Re: Certificate of Appropriateness Application

BAR 17-07-01

425 2nd Street NE

Construct new front wall, front walk, and install gates

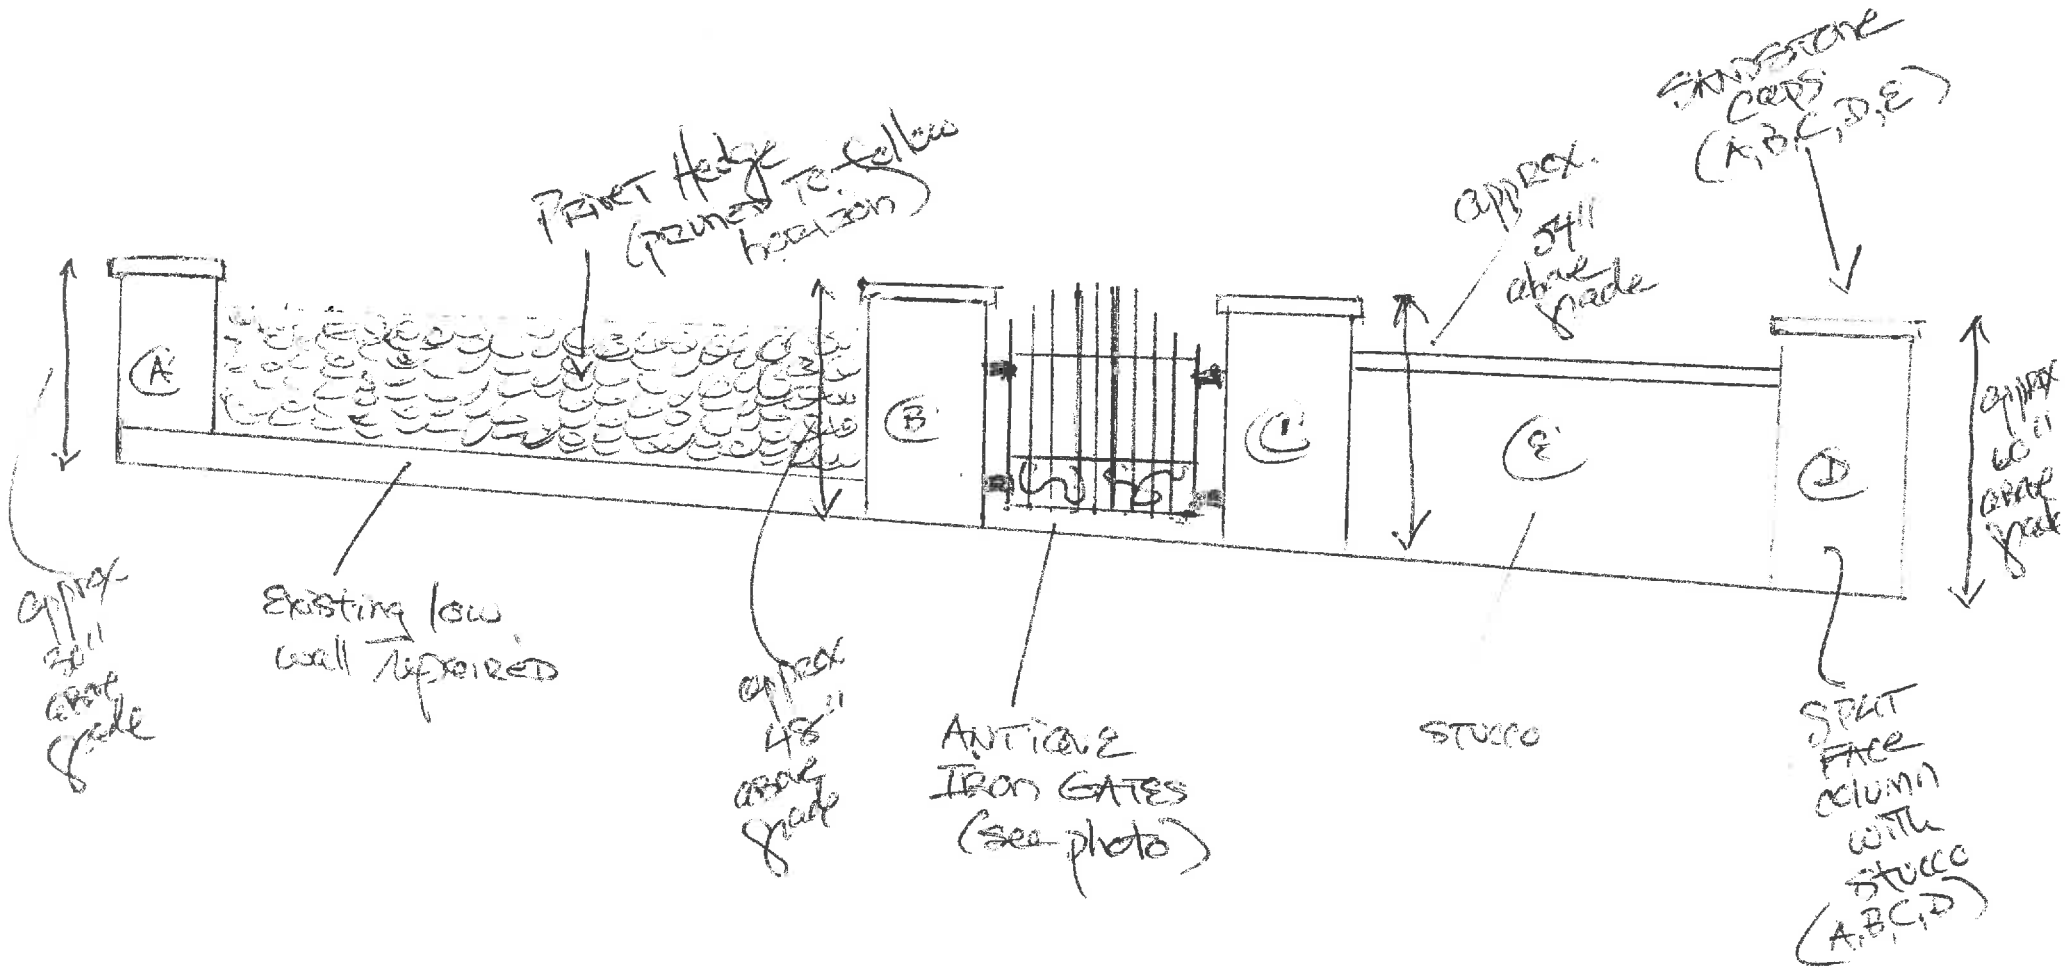
Also, staff suggests the applicant picks either privacy shrubs or a stuccoed wall to present a more cohesive design, instead of both along the structures primary street frontage.

Staff has requested a plan view of the proposed improvements, and a scaled drawing of the proposed wall. The BAR should see a photo of the gate, a sample of the sandstone pavers and the stucco color.

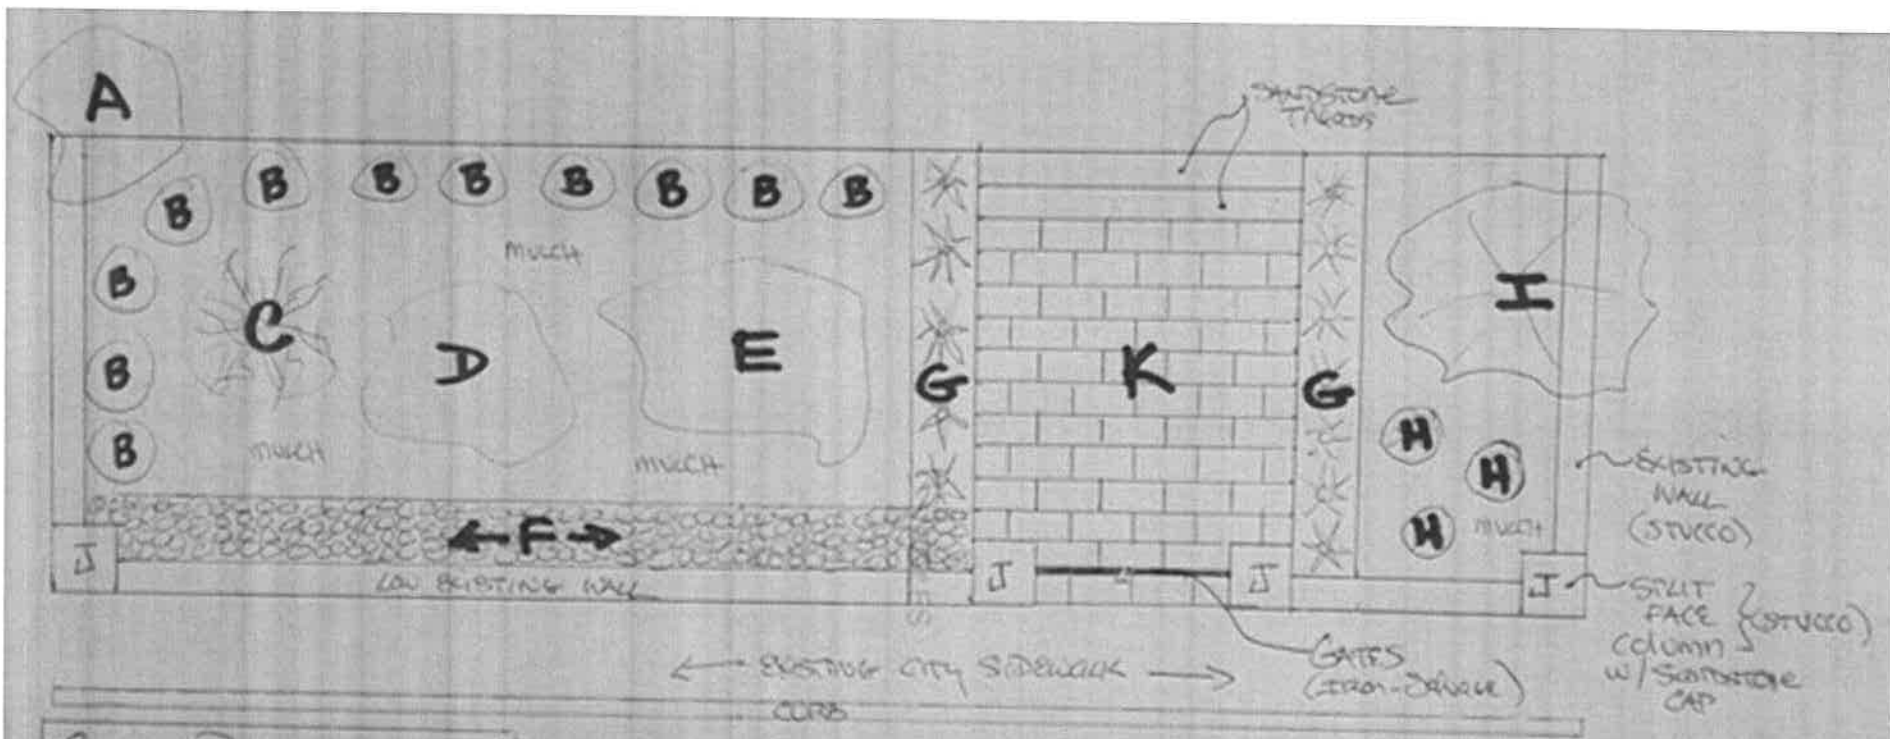
- I agree that the tree in the front yard probably needed to be removed for safety reasons.
- I suggested omitting the new section of wall and corner pier on the north side of the new gates. That wall would be a bit of an anomaly downtown and would remove historic low wall. Its height would exceed our guidelines.

- Instead, he could extend the proposed hedge on the south side of the gates on the north.
- While there are some precedents of privet hedge on 2nd, I did recommend that he consider some other species to avoid the invasive potential. Some alternatives include wax myrtle, inkberry, boxwood, japanese holly.

- I'm not sure where other board members are on the use of sandstone. I suggested that it would be appropriate on the walkway, but I did not feel it would be appropriate on the stair and suggested leaving the existing brick stair. Though it is not original, other foundation piers are brick and this material seems more associated with the house. He clarified that his intention had been to use thicker sandstone treads and that they would replace the top brick treads. (not the thin sandstone shown in some of the photos).

- I don't have a big issue with the piers and iron gate, though their proportion should be considered and height should be minimized.
- Didn't mention this on site w/ Jim, but a nice native to consider in lieu of the paperbark maple is a chalk maple, which is very similar in scale.

- 1) Replace the front walk with brick.
Please note: The brick that was removed was wire cut brick from the 1980s. We would like to replace the brick with period brick, circa early 1900s.
- 2) Replace the front pillars with pillars of the same height that were removed. These pillars would be the same split face look as before, but stuccoed and capped with 2" thick solid sandstone.
- 3) Cancel our proposal to install gates.
- 4) Select low hedging based on Mr. Gastinger's recommendation.
